## HISTORIC AND DESIGN REVIEW COMMISSION

September 21, 2016

**HDRC CASE NO:** 2016-366  
**ADDRESS:** 131 W MULBERRY AVE  
**LEGAL DESCRIPTION:** NCB 1768 BLK 3 LOT 10 & W 25 FT OF 11  
**ZONING:** R4 H  
**CITY COUNCIL DIST.:** 1  
**DISTRICT:** Monte Vista Historic District  
**APPLICANT:** Richard Specia  
**OWNER:** Monica Dobie, Richard Daly  
**TYPE OF WORK:** New window fenestration  
**REQUEST:**

The applicant is requesting a Certificate of Appropriateness for approval to install three wood windows on the first floor east elevation with same profile as existing windows.

# PLAN VIEW N.T.S.

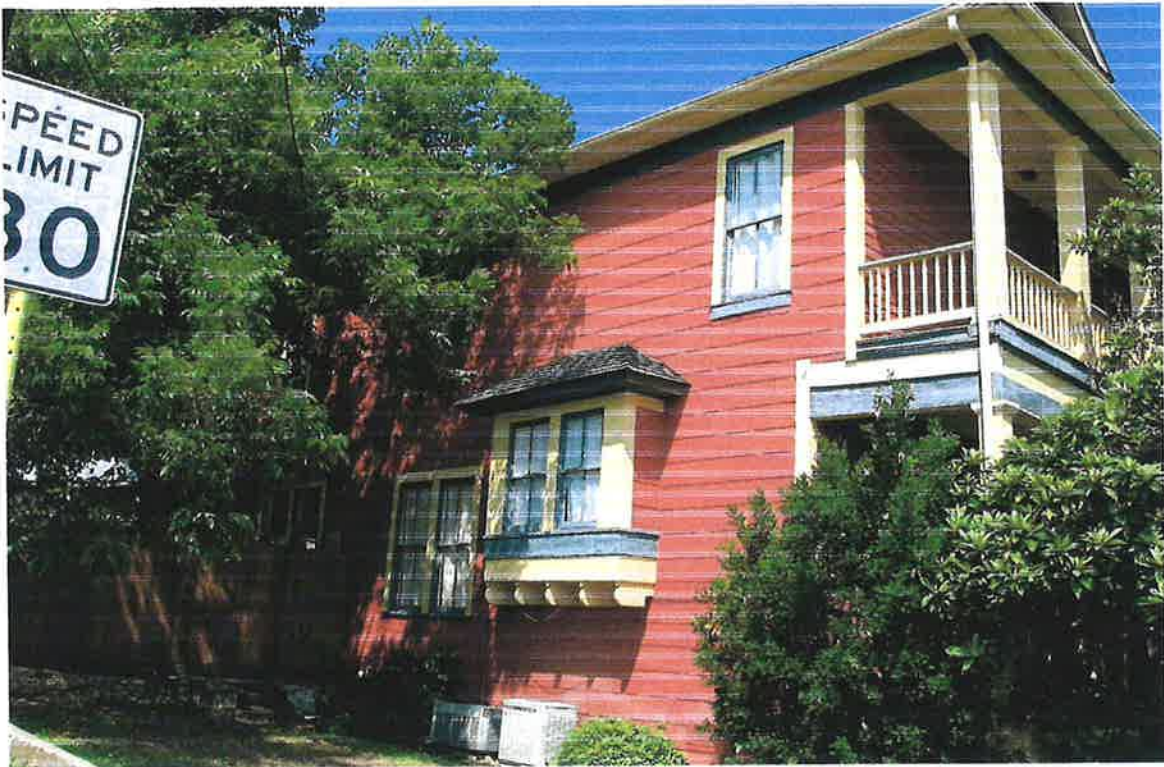
↑  
new  
windows

new  
windows

Staff recommends approval based on findings a and b with the following stipulation that the new windows feature clear glass, feature the existing exterior muntin profile and size, and be inset within to match the profile of those windows existing.

**WOOD DOUBLE HUNG - WIDE RAILS**  
**VERTICAL SECTION**  
**SCALE: 6" = 1' 0"**

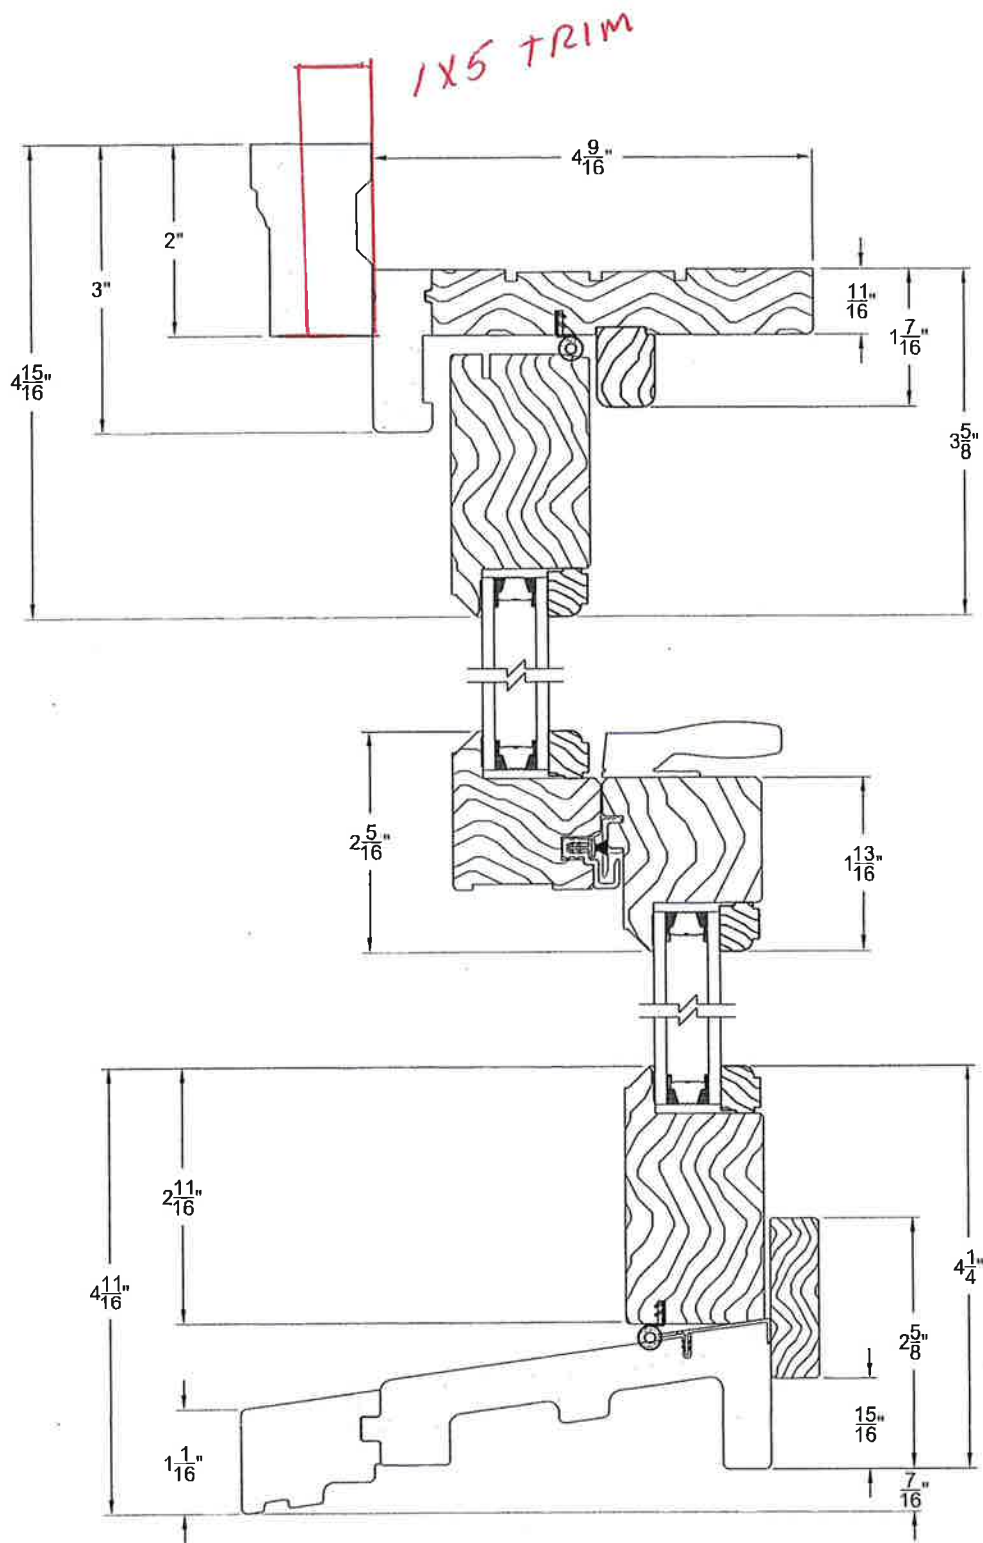
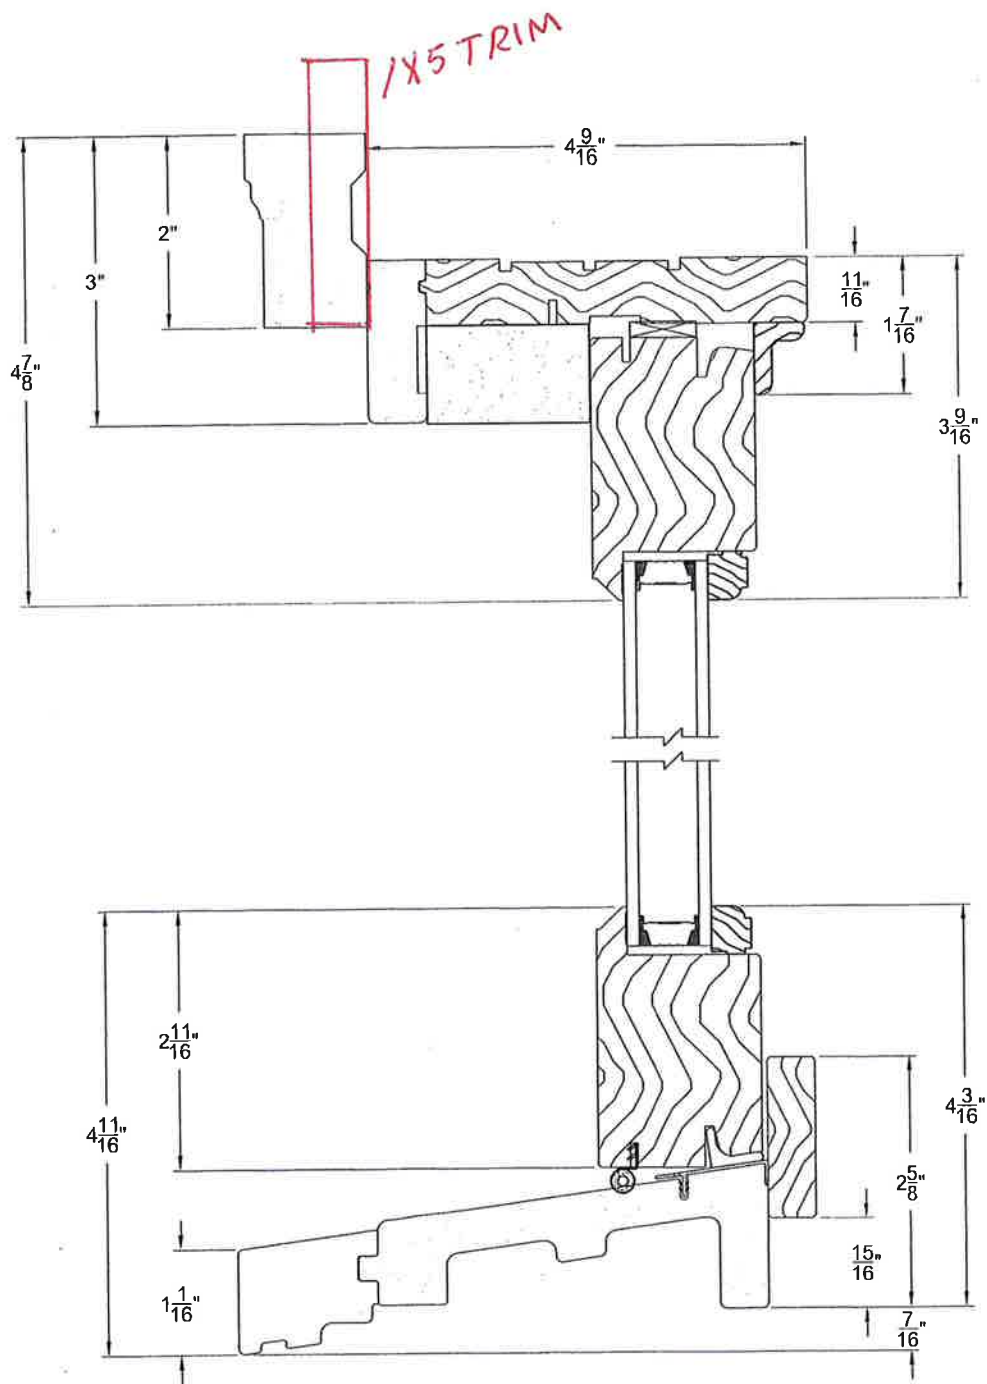
- a. The home at 131 W Mulberry is a Prairie four-square with covered front porch, a second floor balcony and wood siding. It was identified as contributing in the 1975 designation survey.
- b. The home has several configuration of wood windows including 2 over 2, 1 over 1, and 8 over 4. The applicant is proposing to create 3 new window openings and install 3 wood windows: two 3 by 2 fixed windows and one 9 over 6. According to the Guidelines for Exterior Maintenance and Alterations 6.B., new openings should be compatible in size, scale, shape proportion and material; new windows should match the historic windows in terms of size, type configuration, material, form and appearance; muntins should not be false. Staff finds the proposed windows compatible with the existing historic windows, and thus consistent with the Guidelines.
